# UNITED STATES PATENT AND TRADEMARK OFFICE

APPLICATION NO.	FILING DATE	FIRST NAMED INVENTOR	ATTORNEY DOCKET NO.	CONFIRMATION NO.
10/673,643	09/30/2003	Victor T. Massey	081589-0306133	1141
28410 7590 01/11/2008 BERENATO, WHITE & STAVISH, LLC 6550 ROCK SPRING DRIVE SUITE 240 BETHESDA, MD 20817			EXAMINER STRIMBU, GREGORY J	
			ART UNIT 3634	PAPER NUMBER
			MAIL DATE 01/11/2008	DELIVERY MODE PAPER

<b>Office Action Summary</b>	<b>Application No.</b>		<b>Applicant(s)</b>	
	10/673,643		MASSEY ET AL.	
	<b>Examiner</b>		<b>Art Unit</b>	
	Gregory J. Strimbu		3634

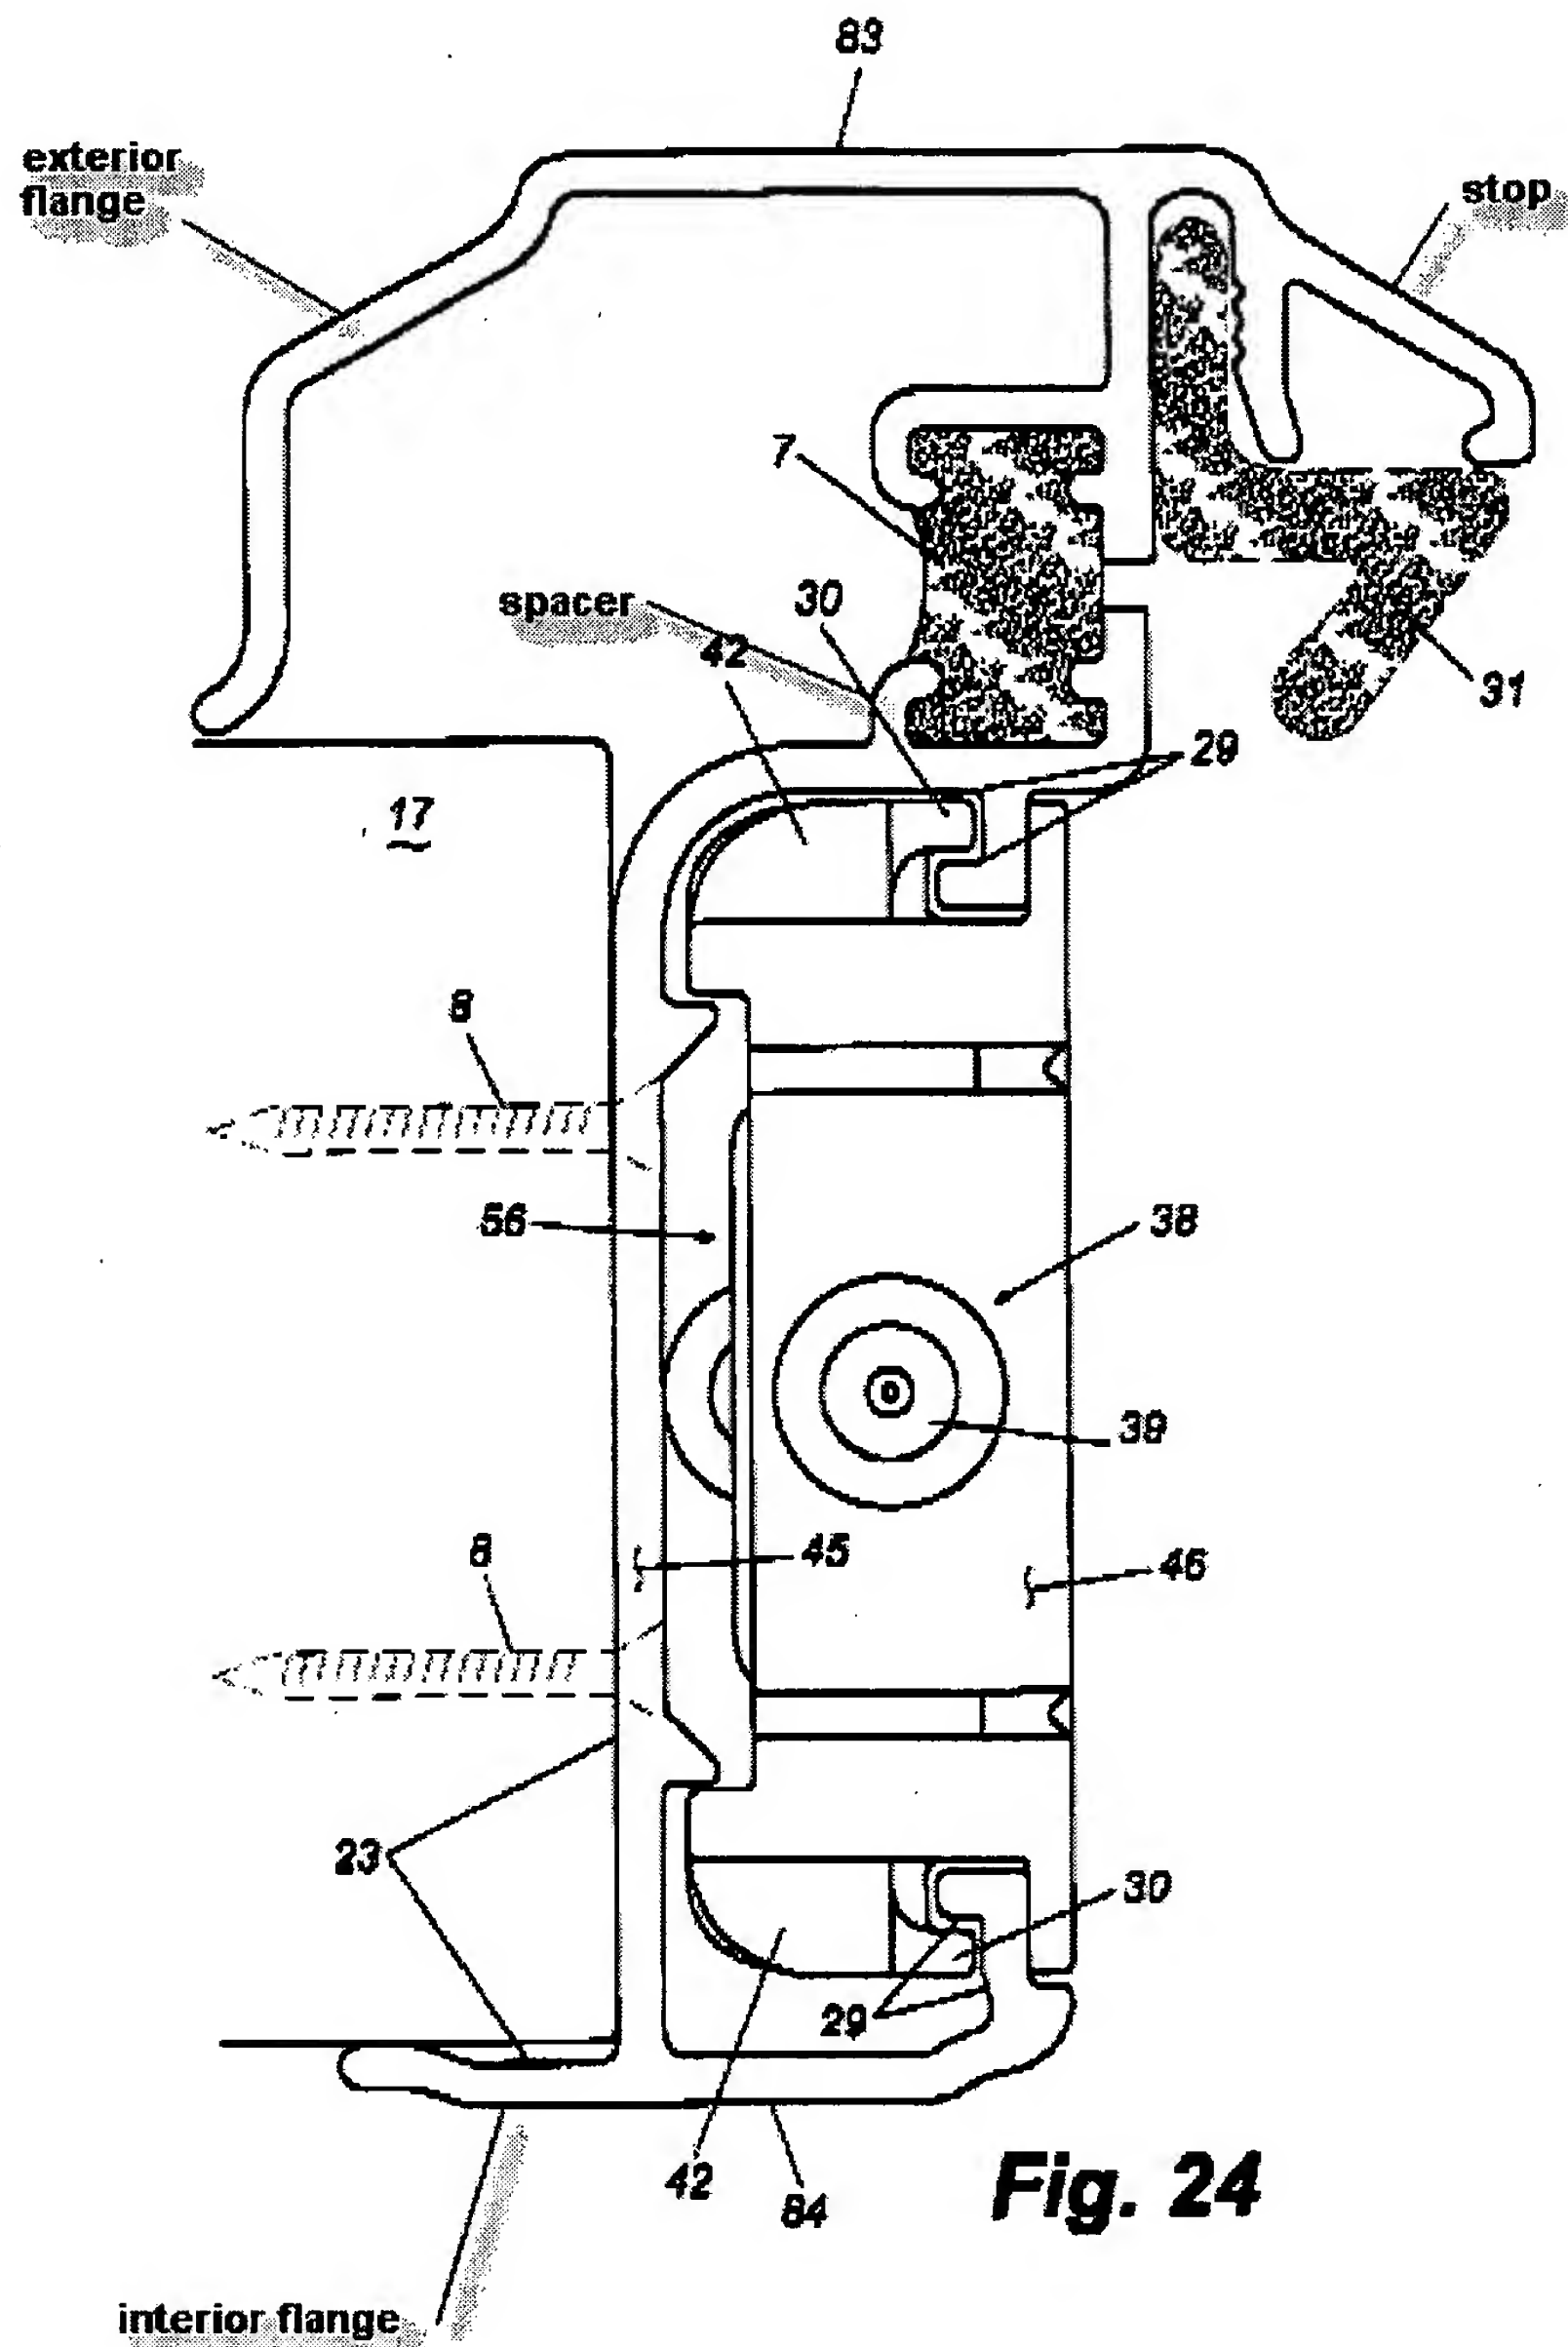
Claims 1-21 and 32-48 are rejected under 35 U.S.C. 103(a) as being unpatentable over Massey et al. (6491326) in view of Hendrickson et al. (US 6684571). Massey et al. discloses an astragal assembly 27 for attachment to a passive door 17 having an interior surface, an exterior surface opposite to the interior surface, and an outer edge extending from the exterior surface to the interior surface, comprising: a metallic rail 28 having an exterior portion 83, an interior portion 84 spaced from and opposed to the exterior portion, and a side portion 45 extending between the exterior portion and the interior portion disposed opposite the outer edge of the passive door when the astragal assembly is affixed thereto, a spacer (labeled below) extending outwardly from a major surface of the side portion and having a distal end to maintain an air gap between a surface of the outer edge of the passive door and the side portion of the metallic rail when the astragal assembly is affixed thereto to allow air flow between the outer edge of the passive door and the side portion of the metallic rail, an interior flange (labeled below) extending away from where said interior portion meets

said side portion to engage the interior surface of the passive door, and an exterior flange (labeled below) opposite said interior flange and extending away from where said exterior portion meets said side portion to engage the exterior surface of the passive door, wherein an elongated open channel is defined in the metallic rail with sides formed by the exterior portion and the interior portion and a base formed by the side portion, the elongated open channel having an opening extending between the exterior portion and the interior portion and opposed to the side portion; and an insert 25 retained within the elongated open channel in the metallic rail, a stop (labeled below), a gasket 31, a thermal break 7, hooks 29 Massey et al. is silent concerning a wooden insert.

However, Hendrickson et al. discloses an insert 76a having a wood construction.

It would have been obvious to one of ordinary skill in the art to provide the insert of Massey et al. with a wood construction, as taught by Hendrickson et al., to improve the aesthetics of the astragal assembly.

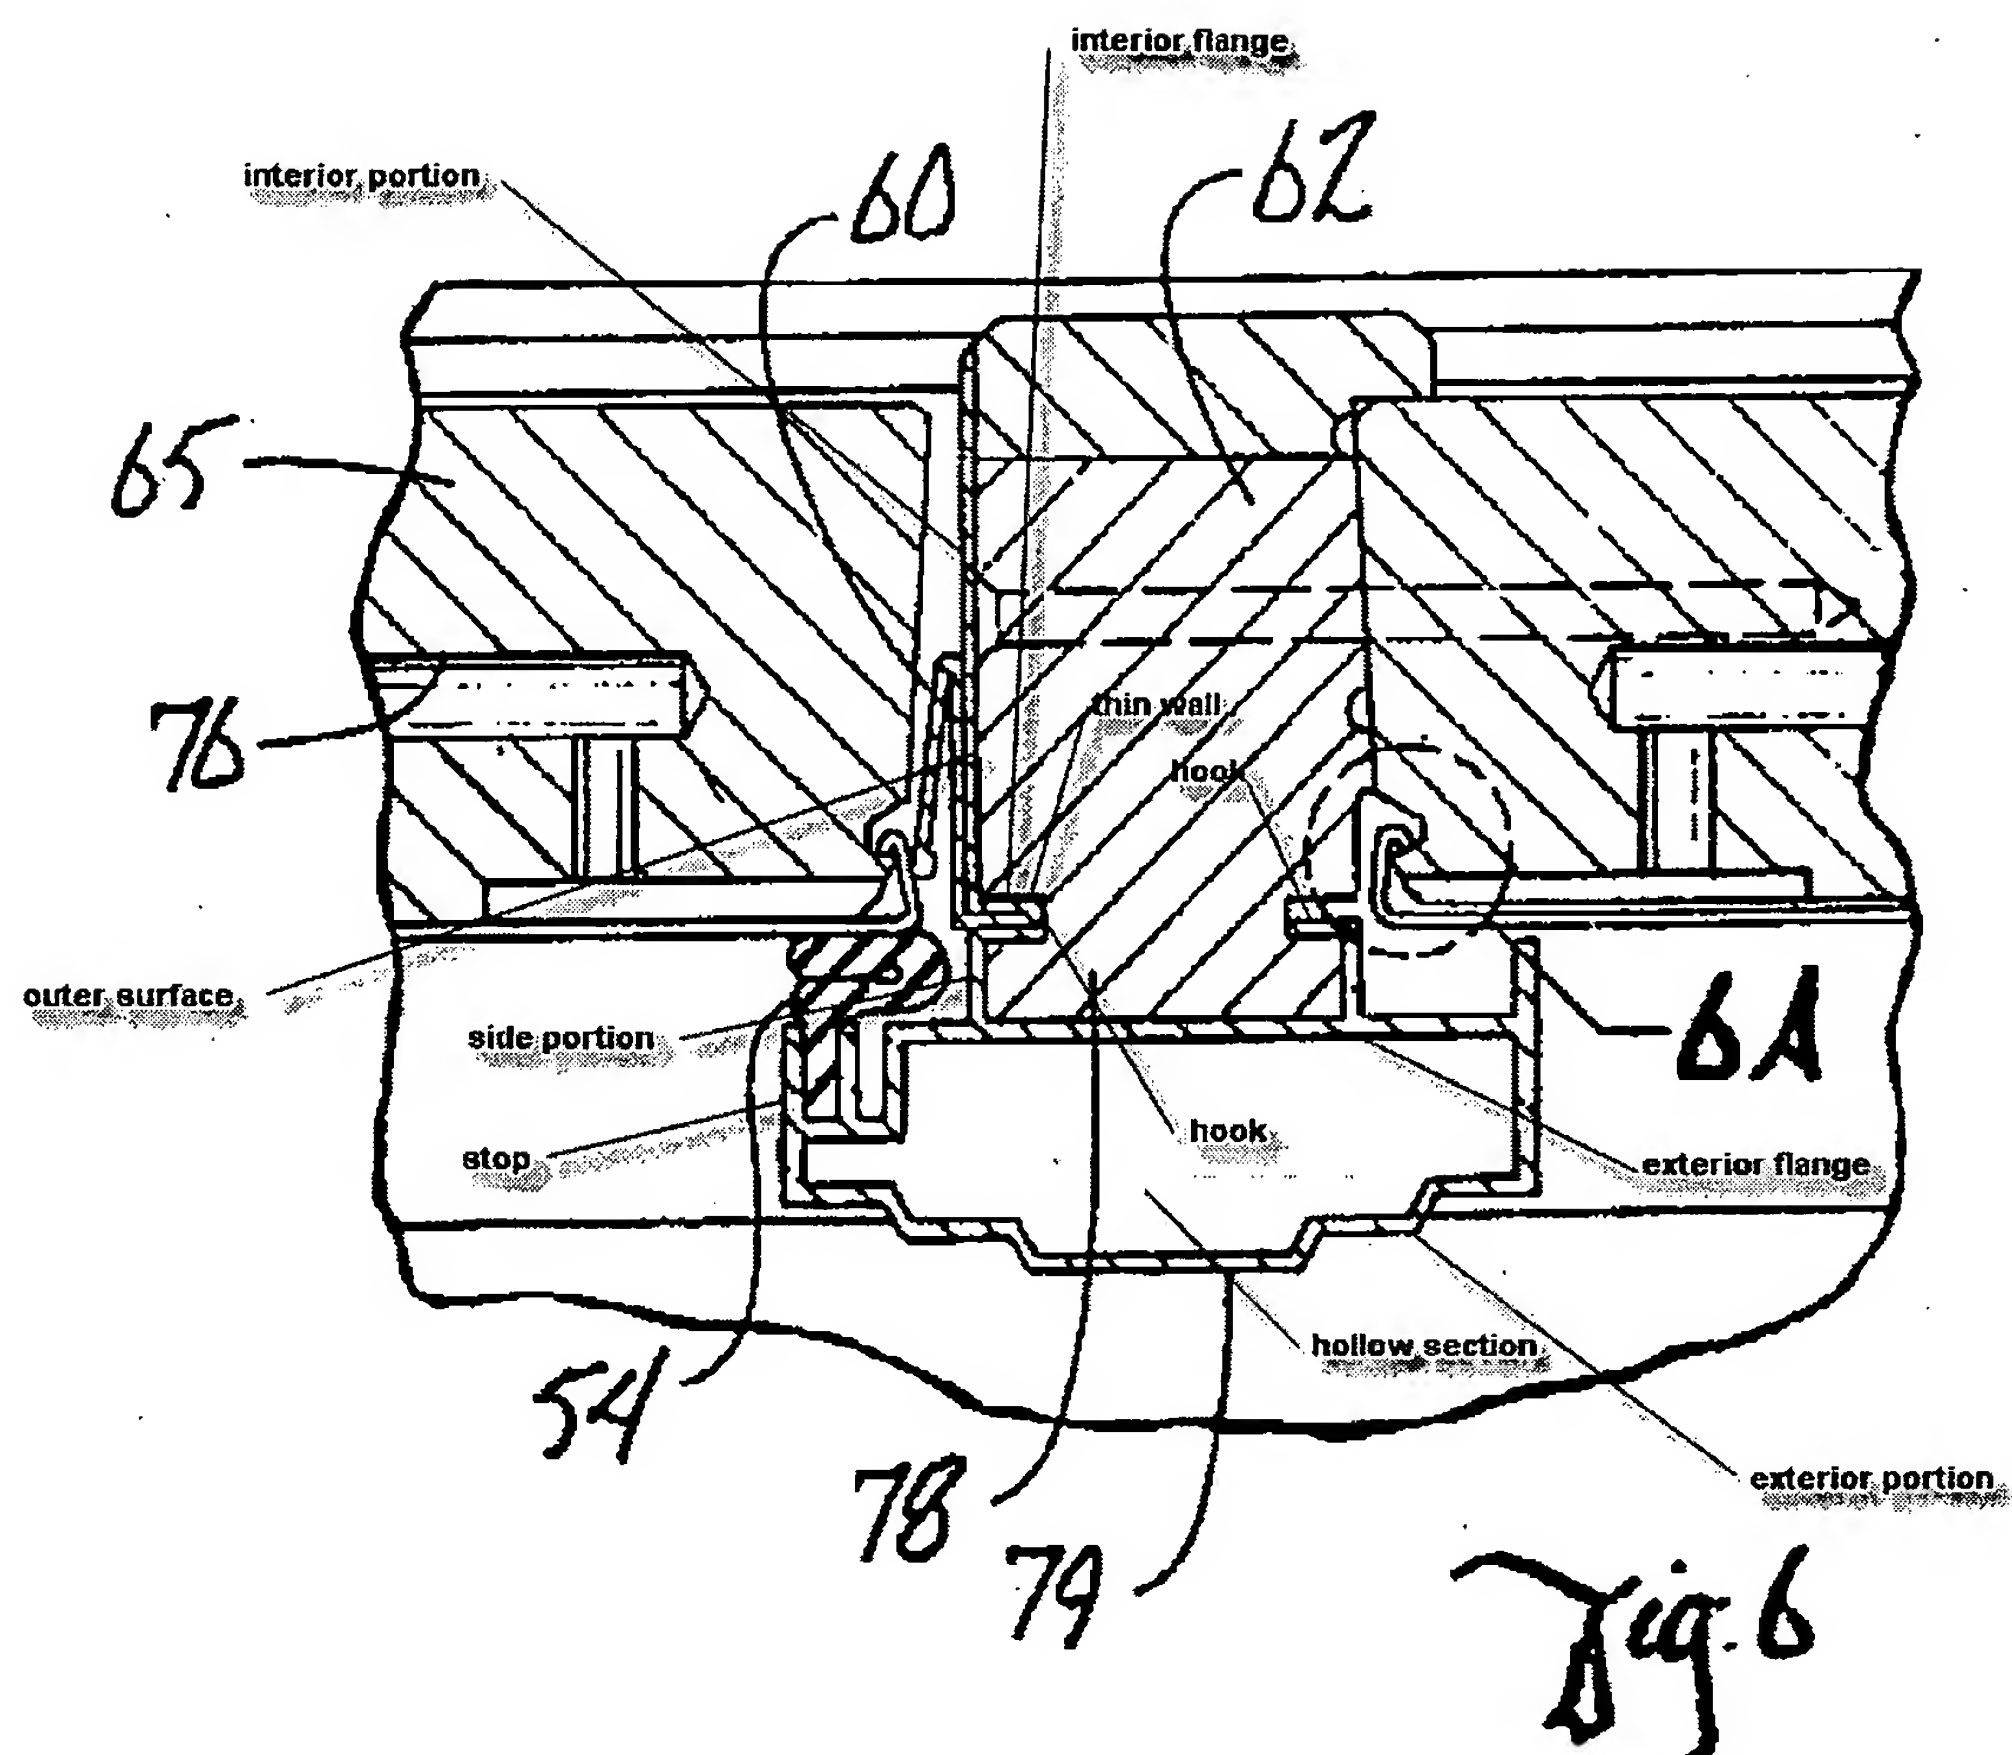
Claims 32-36 and 38 are rejected under 35 U.S.C. 102(b) as being anticipated by Hagemeyer et al. (US 4573287). Hagemeyer et al. discloses an astragal comprising: an extruded aluminum rail 79 with an exterior portion (labeled below), an exterior flange

(labeled below) extending from a first side of said exterior portion, and a stop (labeled below) extending from a second side of said exterior portion opposite to the first side, an interior portion (labeled below) spaced from and opposed to the exterior portion, an interior flange extending from the second side of the interior portion opposite from and substantially parallel to the exterior flange, and a side portion (labeled below) extending between where the exterior portion meets the exterior flange and where the interior portion meets the interior flange, the side portion having a fastening formation and a spacer 60 extending outwardly from a surface thereof; and a wooden insert member 78 retained substantially within a channel in the extruded aluminum rail formed by the exterior portion, the interior portion and the side portion, wherein the insert presents an outer surface (labeled below) for attachment to hardware, and the spacer extends away from the channel, a hollow section (labeled below) and hook (labeled below), the interior portion includes a thin wall (labeled below) and a hook (labeled below) extending into the channel, the side portion includes a thermal break comprising the air pocket formed between the side portion and the seal, a strike plate (not shown).
